### **ADDENDUM #1**

Title: CCRI Knight Campus 2nd Floor Laboratory Renovations

### **ADDENDUM #1**

### Knight Campus - 2<sup>nd</sup> Floor Laboratory Renovations at Community College of Rhode Island 400 East Avenue Warwick, Rhode Island

**GEISSER CMU WALL CRACK REPORT**

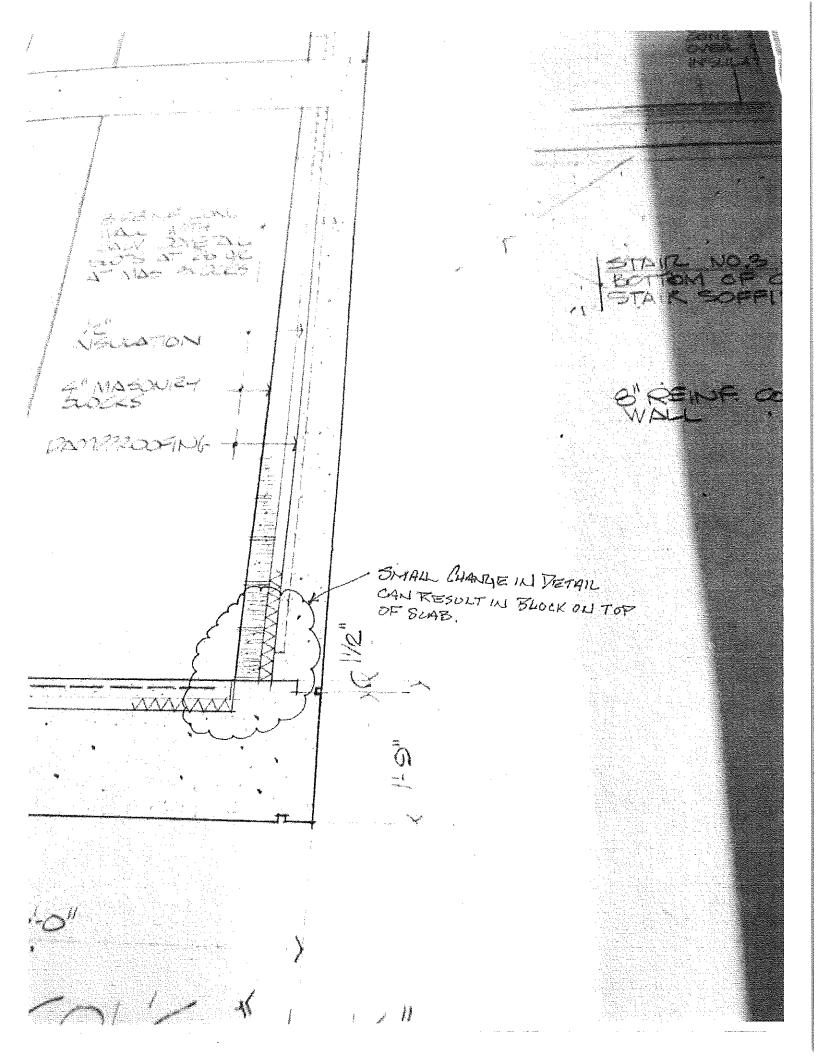
The construction detail at this location, see attached, depicts the wall sitting on top of an exterior concrete beam adjacent to the interior slab, which was cast over ridged insulation. A small change in the layout during construction could result in the wall being constructed over the slab rather than the beam. Over time the concentrated weight of the block could compress the insulation resulting in the movement that has taken place.

To repair the existing damage the block wall will need to be temporarily shored so the affected portion of the slab and insulation can be removed. New insulation can then be placed, and the perimeter of the slab removal area can be reinforced with dowels, in the remaining slab and the adjacent exterior beam. A new slab section can be cast, and the damaged section of the block wall can then be rebuilt.
